ADDENDUM #2

Project Name:
Newton Correctional IPI Homes for Iowa Phase II
A/E Project # 02401959.001
DAS# 9239.02 & 9239.03
RFB 923902-01
Addendum #2
Dated: August 20, 2025

Addendum Number: 002

Project Name: Newton CF IPI Homes for Iowa Phase II

CIVIL COVER SHEET

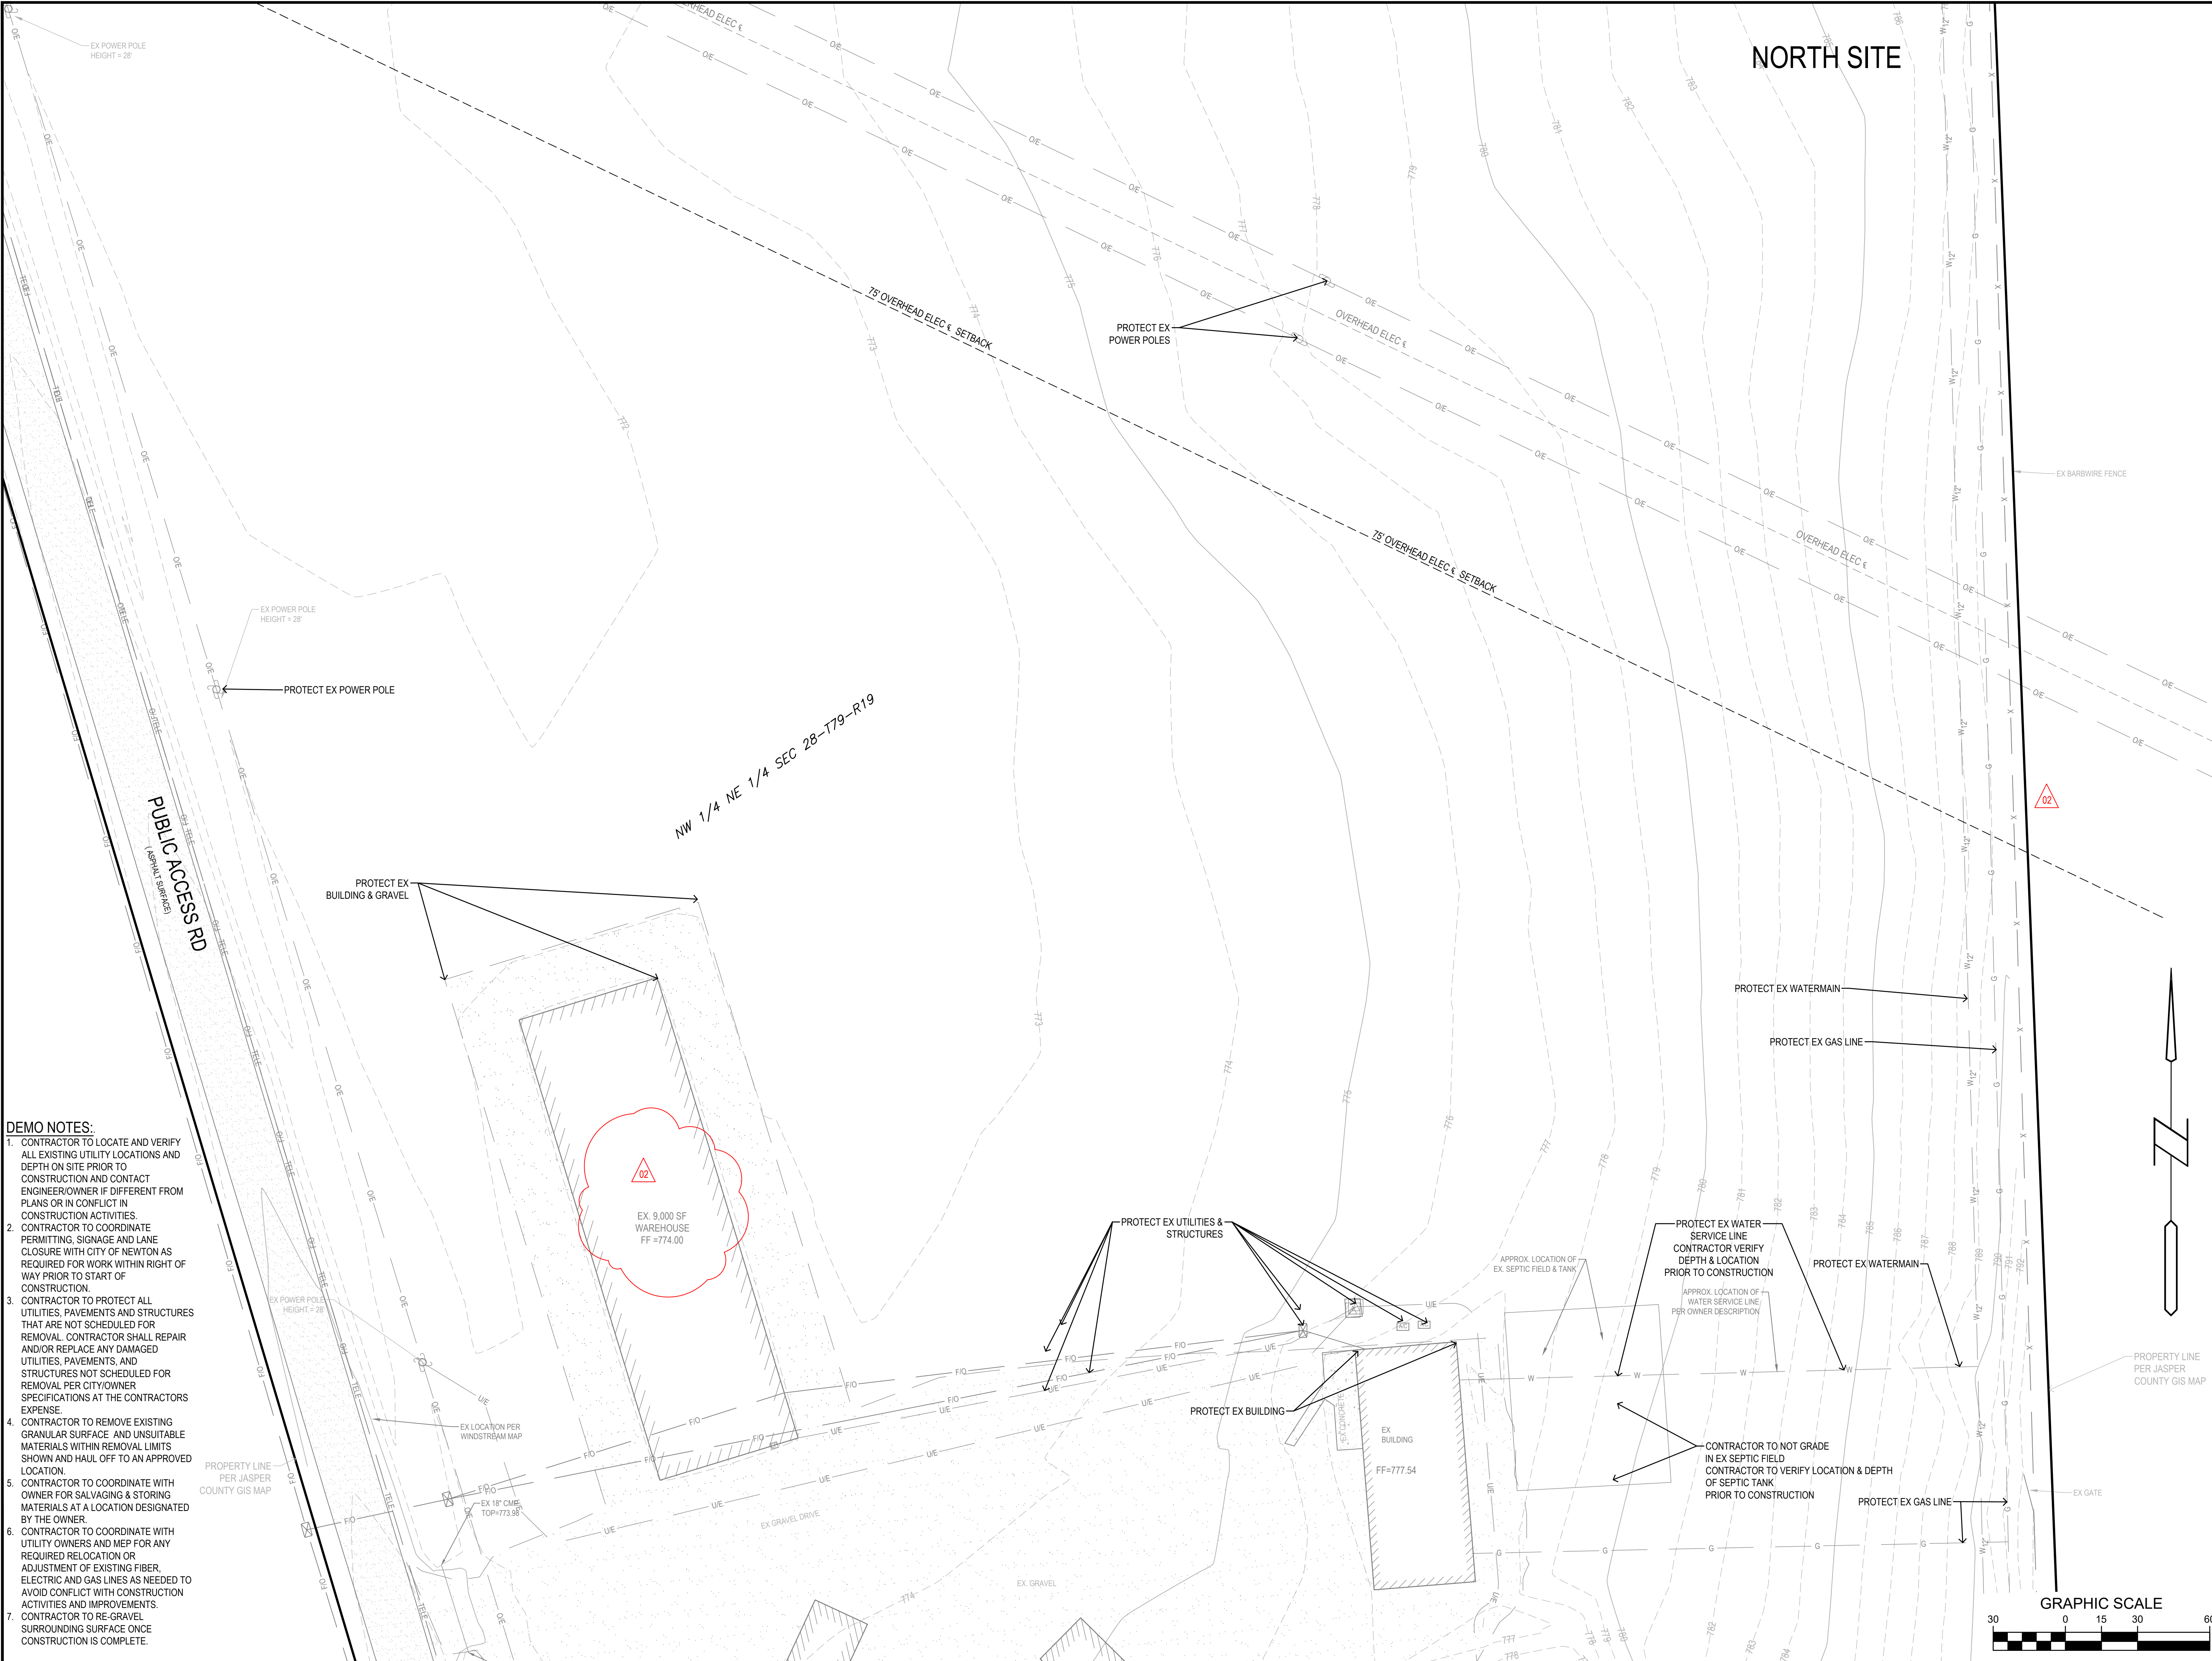
Item No. 9 Corrected Finished Floor Elevation on Existing Building.

SHEET NUMBER:
C2.0
PROJECT NO.: 02401959.001

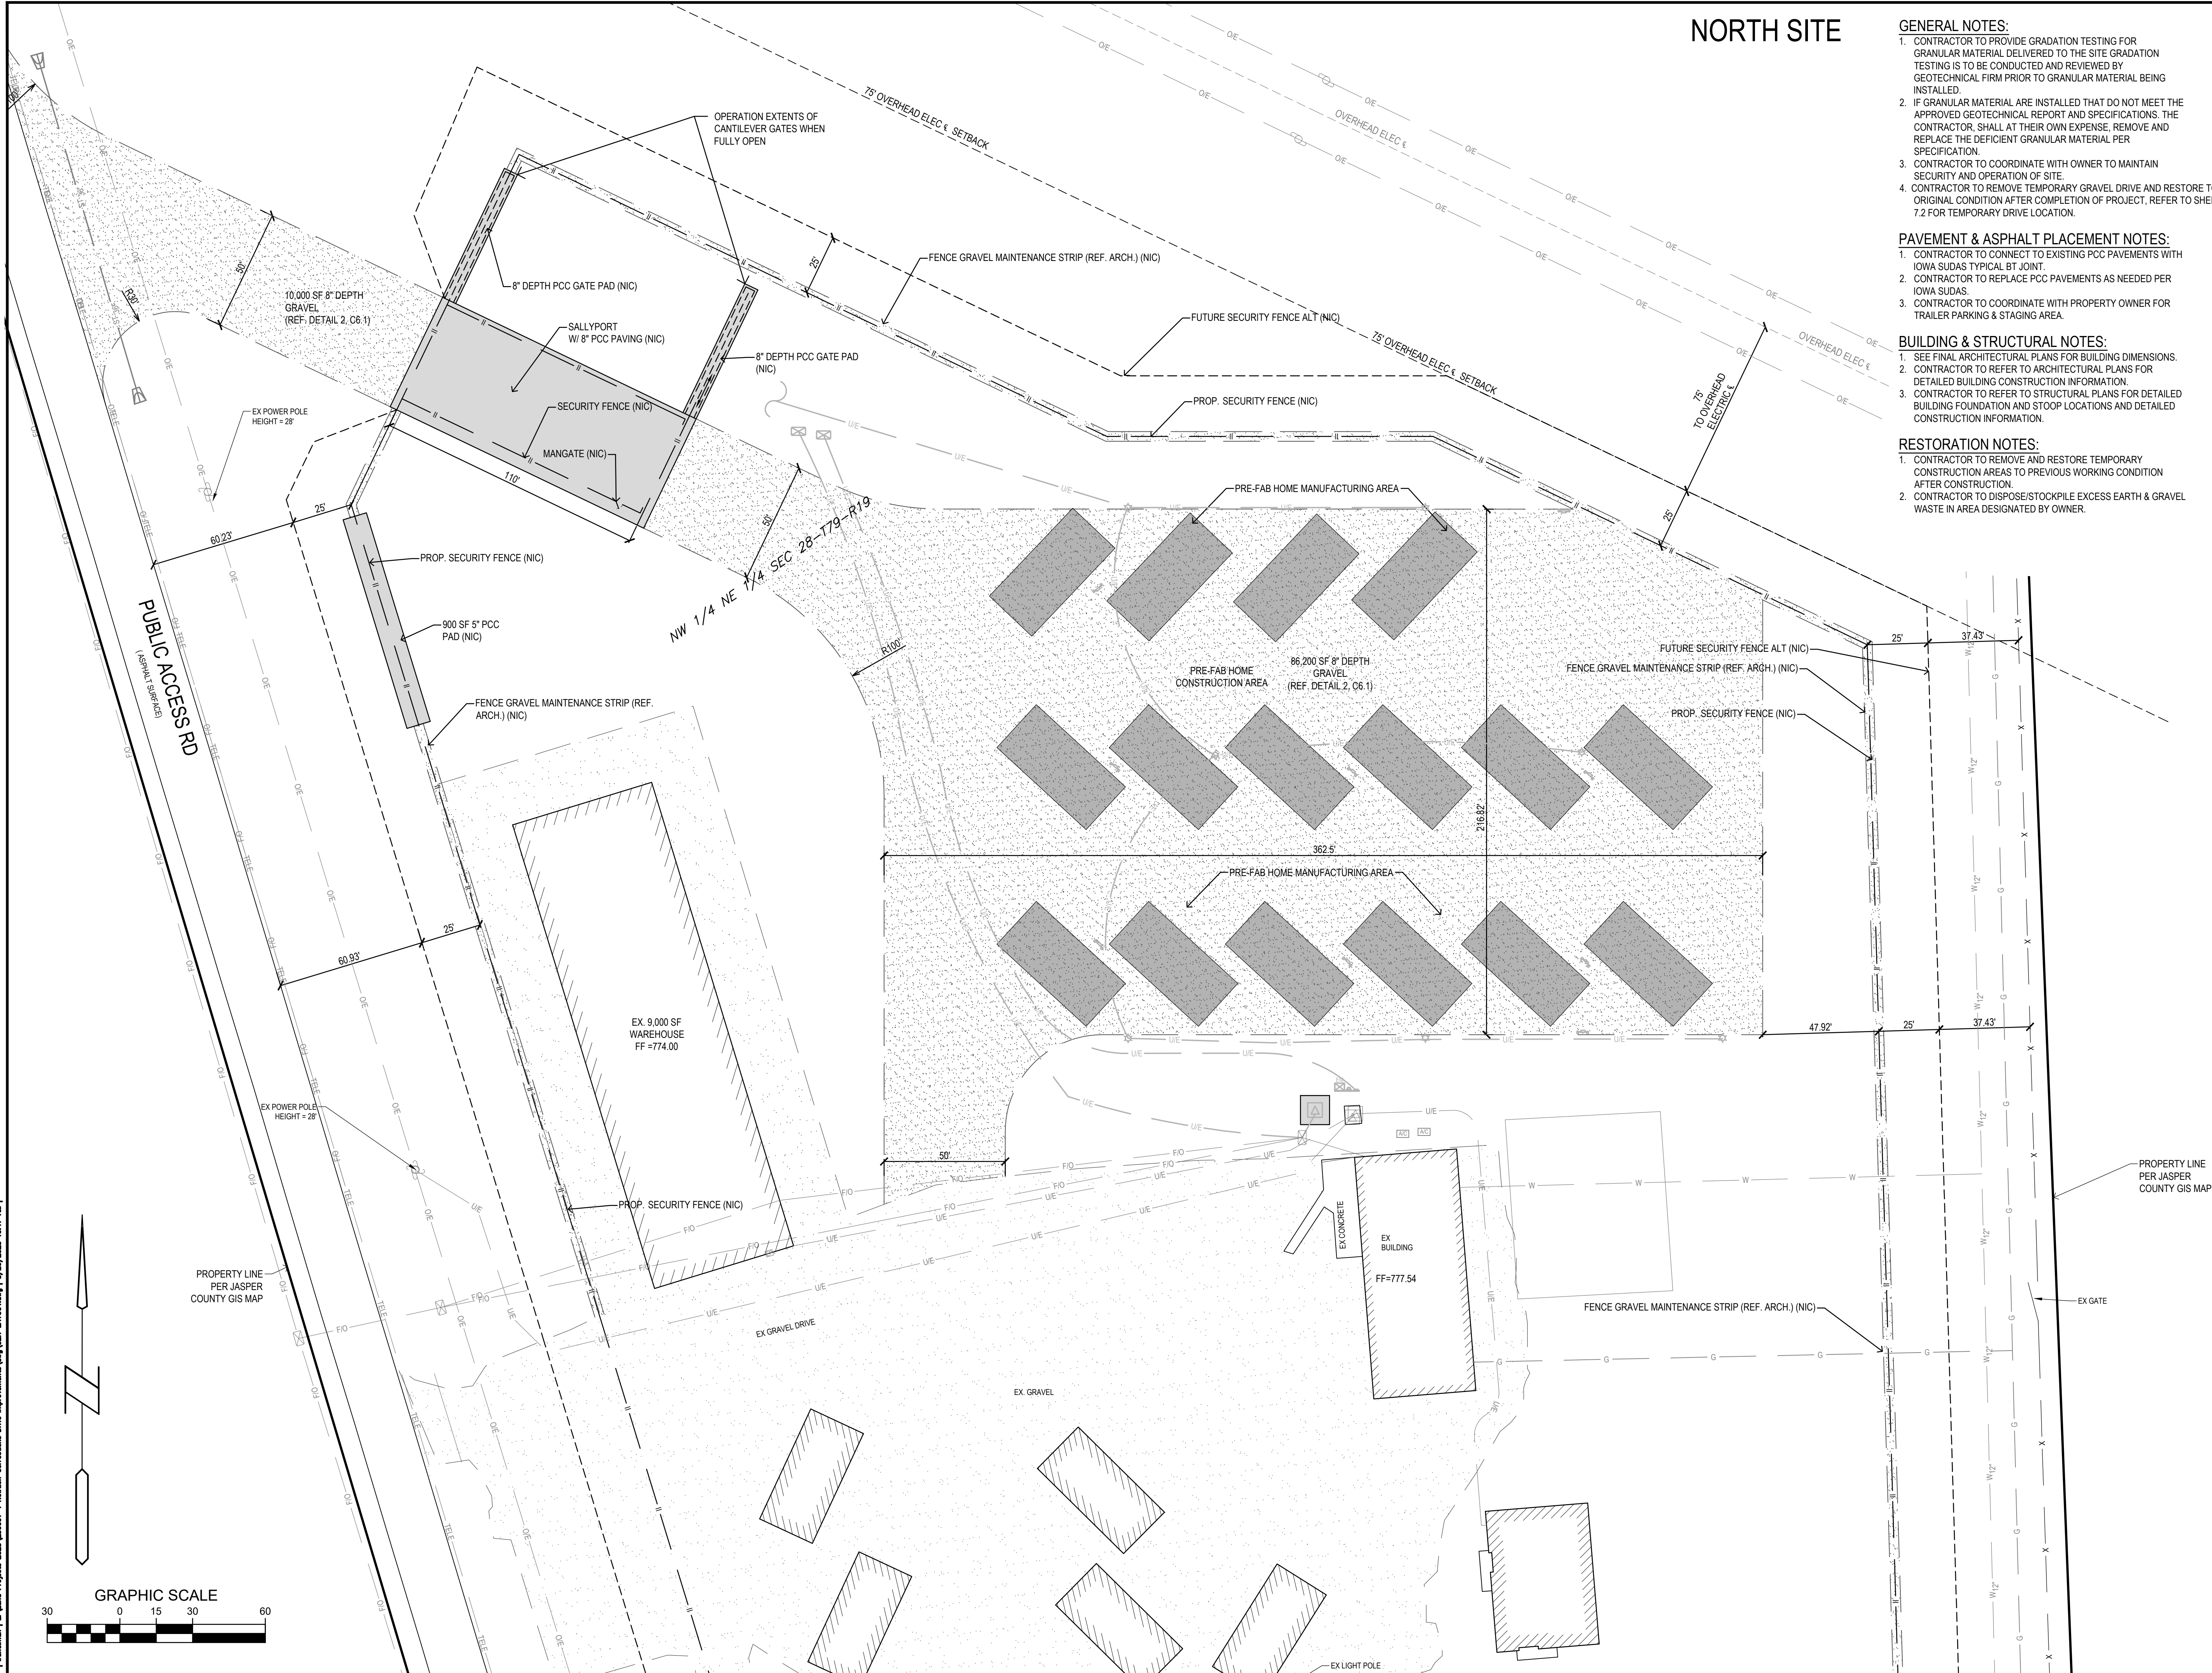
Item No. 11 Darkened Proposed Electric Lines.

Item No. 12 Added additional Project Notes

SHEET TITLE:
UTILITY PLAN

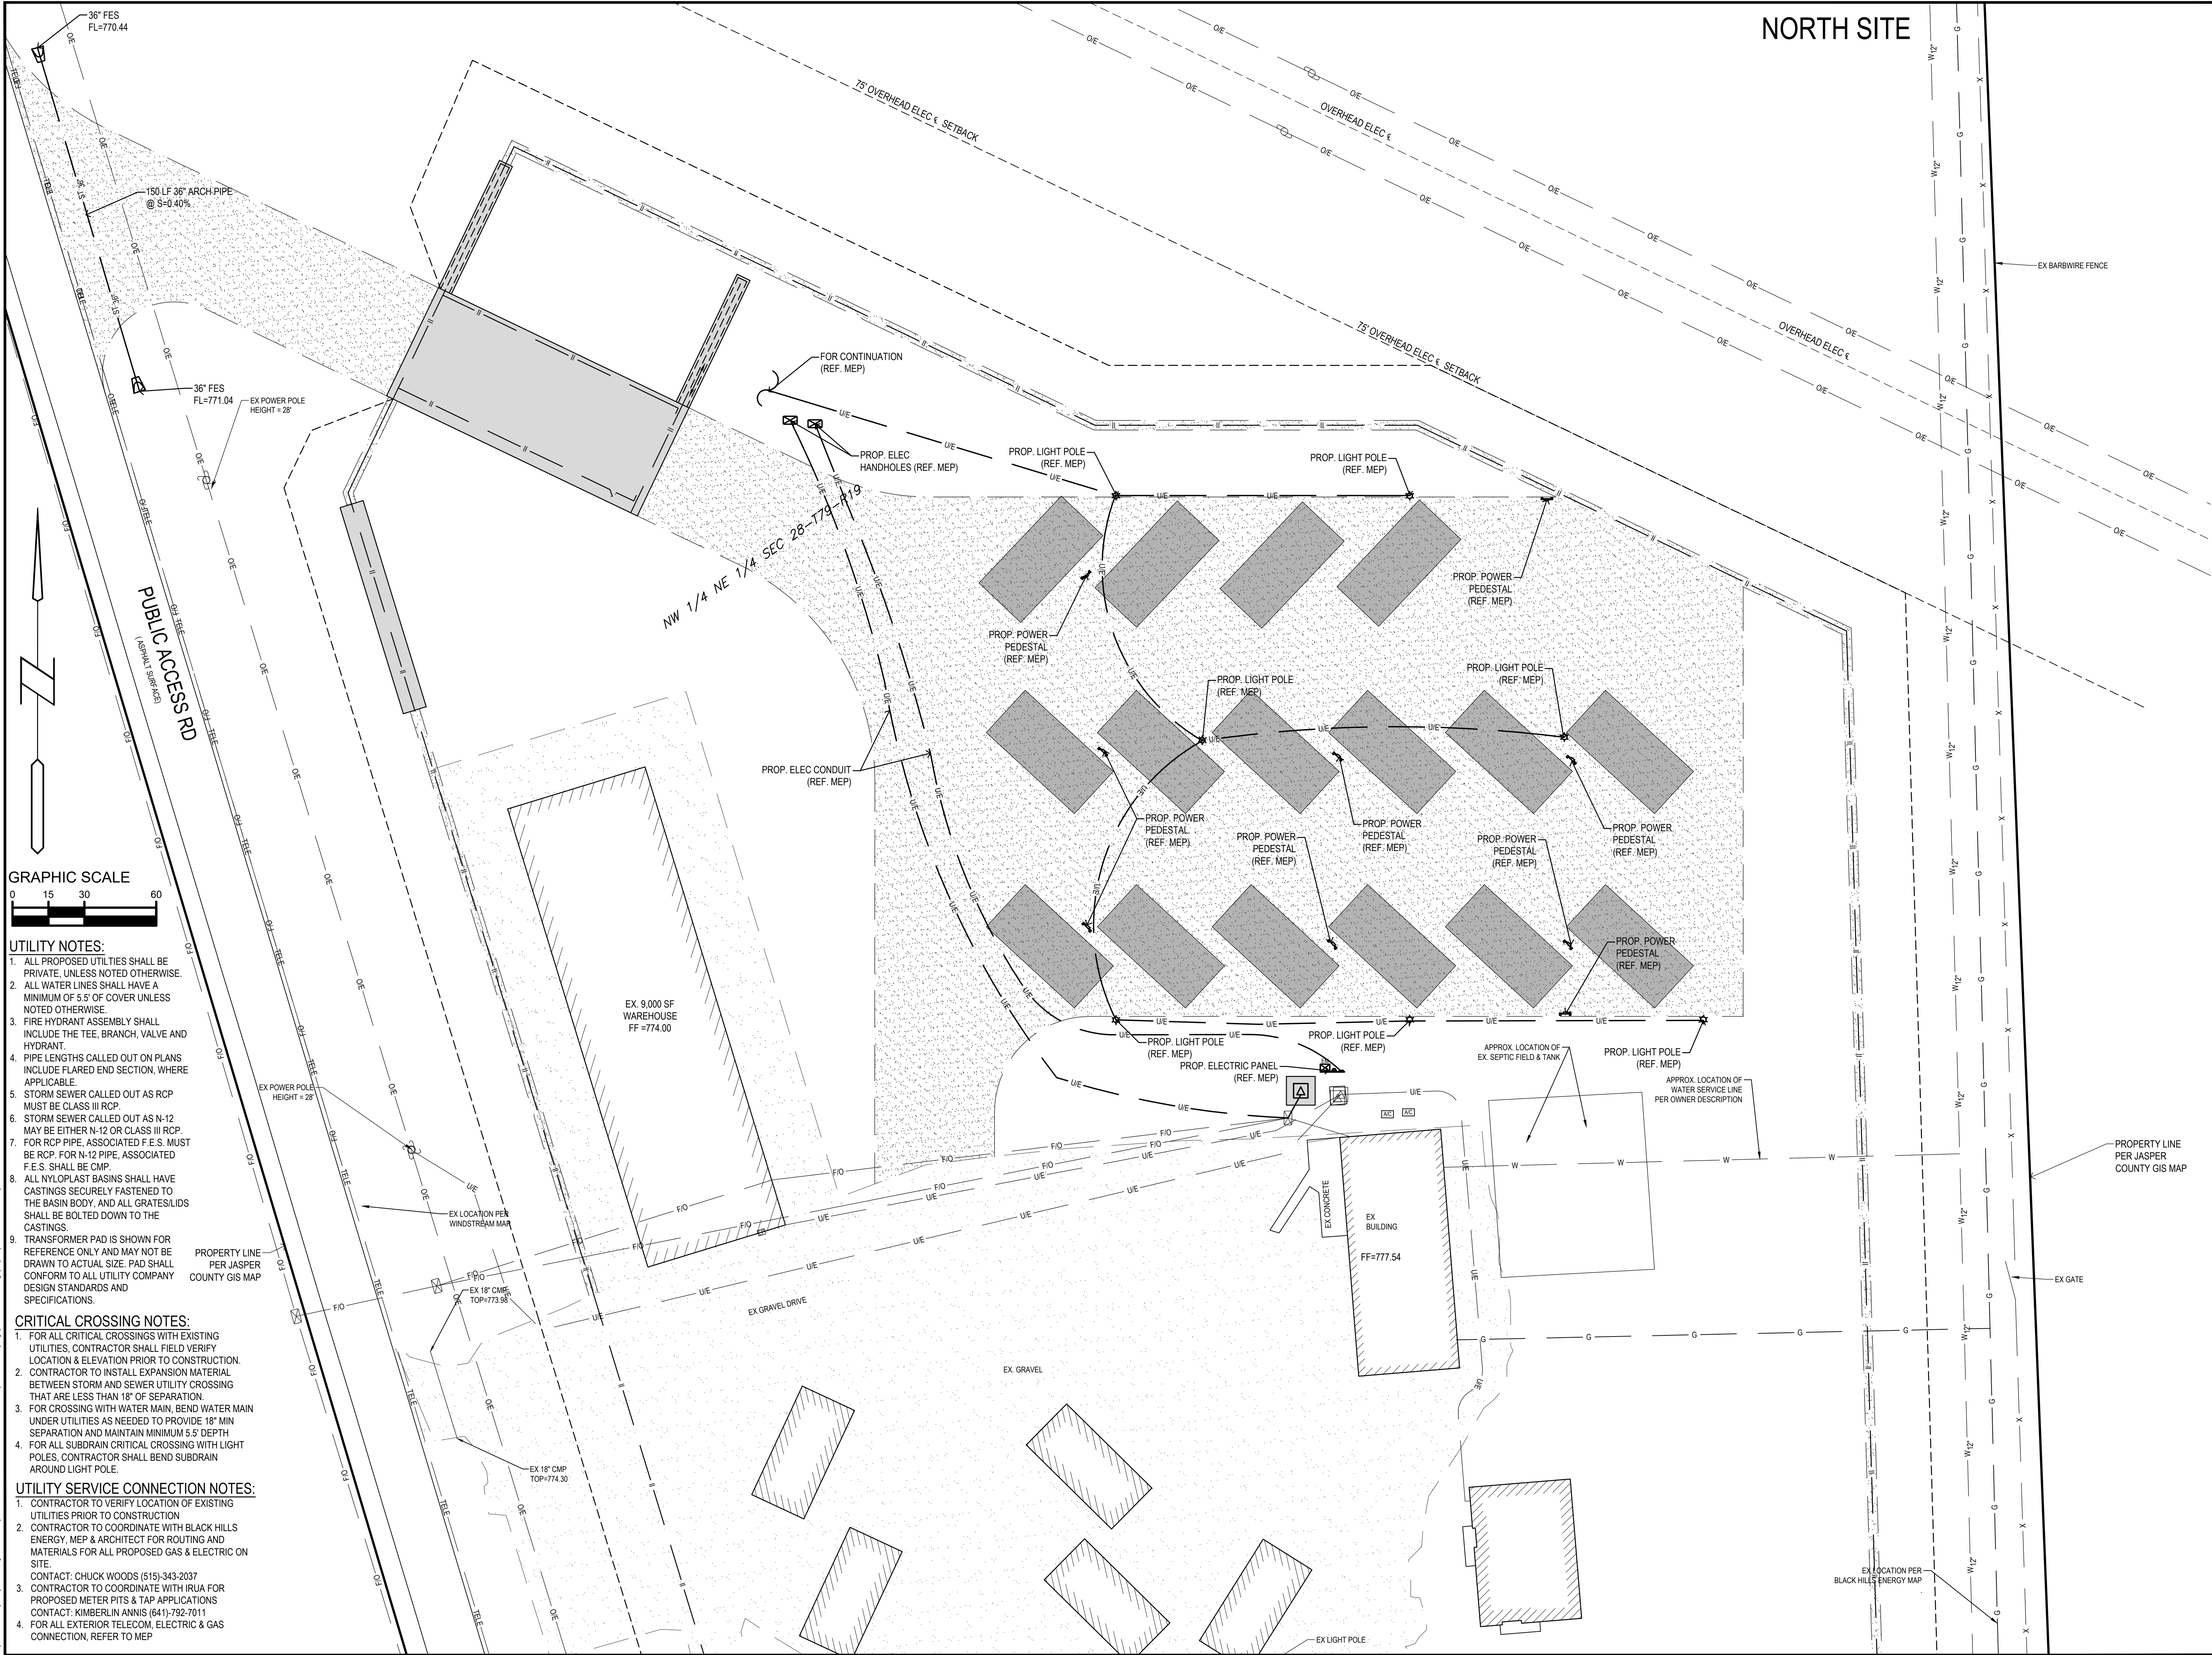
- Item No. 18 Rerouting of Proposed Sanitary Line and Elimination of Old Route. Callouts Added for critical Crossing and Interpolated inverts of Existing Sanitary Line for New Connection.
